Technical product information

Topic	Power steering noise 4.0 V8
Market area	Bentley: worldwide (2WBE),Hongkong-Macau (5HK)
Brand	Bentley
Transaction No.	2042624/2
Level	EH
Status	Approval
Release date

Figure 1

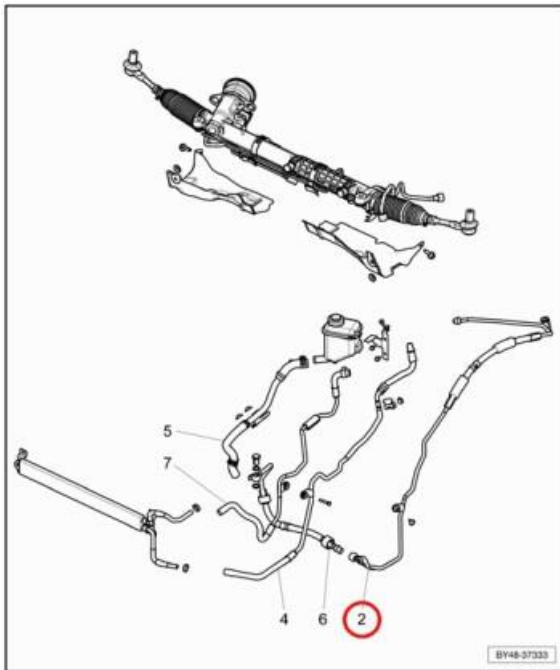
Power steering noise (hiss) audible in cabin emanating from front of car

Variability in hose assembly and fitting can create noise transfer path at rubber mounting points resulting in power steering hydraulic flow audible in cabin

Design change to improve compliance of hose and thus reduce noise radiation

In the event of a qualified report of power steering hiss audible in cabin then replace power steering high pressure hose (2) (see Figure 1) Rep. Gr. 48 Power Steering Pipes – To Remove and Fit

Original part number	Replacement part	Description
4W0422893D	4W0422893H	Hose assembly
